DART AEROSPACE LTD		Work Order:	136986
Description: Crosstube Assembly, Mid Fwd		Part Number:	D206-667-147
Inspection Dwg: D206-667-147 Rev: A		Page 1 of 2

DART AEROSPACE LTD HAWKESBURY, ONTARIO, CANADA	
DRAWING NO. D206-667-147	REV. A SHEET 1 OF 4
TITLE CROSSTUBE ASS'Y (206L MID FWD)	SCALE NTS
COPYRIGHT © 2010 BY DART AEROSPACE LTD THIS DOCUMENT IS PRIVATE AND CONFIDENTIAL AND IS SUPPLIED TO THE EXPRESS CONDITION THAT IT IS NOT TO BE USED FOR ANY PURPOSE OR COPIED OR COMMUNICATED TO ANY OTHER PERSON WITHOUT WRITTEN PERMISSION FROM DART AEROSPACE LTD.

DRAWING NO. D206-667-147	TITLE CROSSTUBE ASS'Y (206L MID FWD)	REV. A	DART AEROSPACE LTD ENGINEERING ORDER		D.E.O. NO. D206-667-147-A-1	SHEET NO. SHEET 1 OF 1	SCALE NTS
DRAWN <i>qp</i>	CHECKED <i>ADS</i>	MFG. APPR. <i>JS</i>	APPROVED <i>MD</i>		DE APPR. <i>MD</i>		
DATE 11.07.15	DATE 11.07.20	DATE 11.07.21	DATE 11/07/21		DATE 11.07.21

DRAWING NO. D206-667-147	TITLE CROSSTUBE ASS'Y (206L MID FWD)	REV. A	DART AEROSPACE LTD ENGINEERING ORDER		D.E.O. NO. D206-667-147-A-2	SHEET NO. SHEET 1 OF 1	SCALE NTS
DRAWN AJS	CHECKED	MFG. APPR.	APPROVED	DE APPR.			
DATE 12.08.02	DATE 12.08.02	DATE 12.08.02	DATE 12.08.02	DATE 12.08.02	DATE 12.08.02

DETAIL P
BONDING STRAP INSTALLATION 2 PL

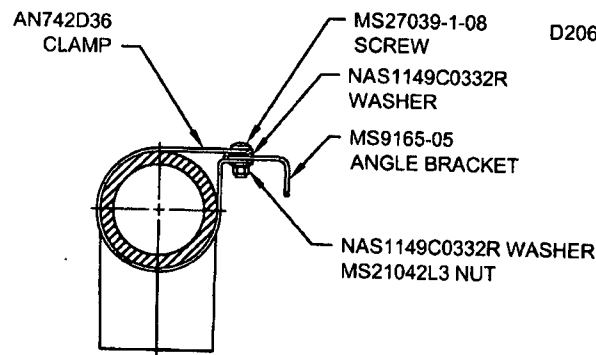
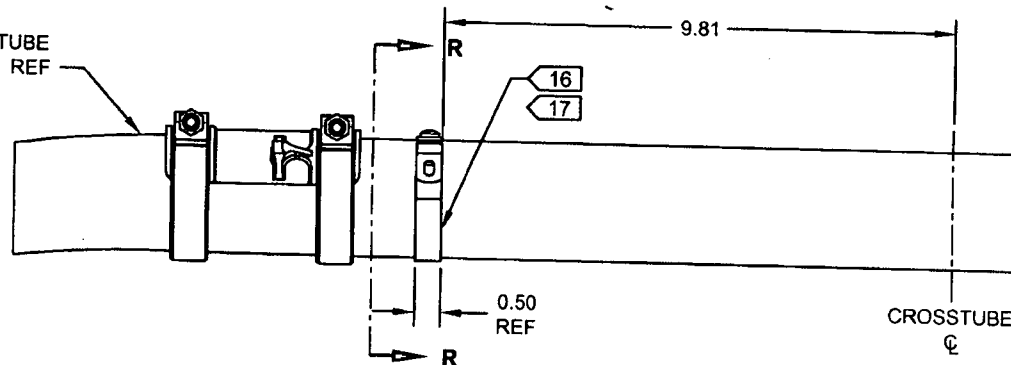
PURPOSE:

ADD ELECTRICAL GROUNDING STRAP

- 16) MASK AREA UNDER CLAMP PRIOR TO PAINTING
- 17) SEAL EDGES WHERE AN742D36 CLAMP MEETS WITH THE CROSSTUBE USING SIKAFLEX-241/-291 OR MIL-S-8802 CLASS B2 OR PROSEAL 890 SEALANT
- 18) PERFORM RESISTANCE CHECK TO ENSURE MAX RESISTANCE IS 10 MILLIOHMS
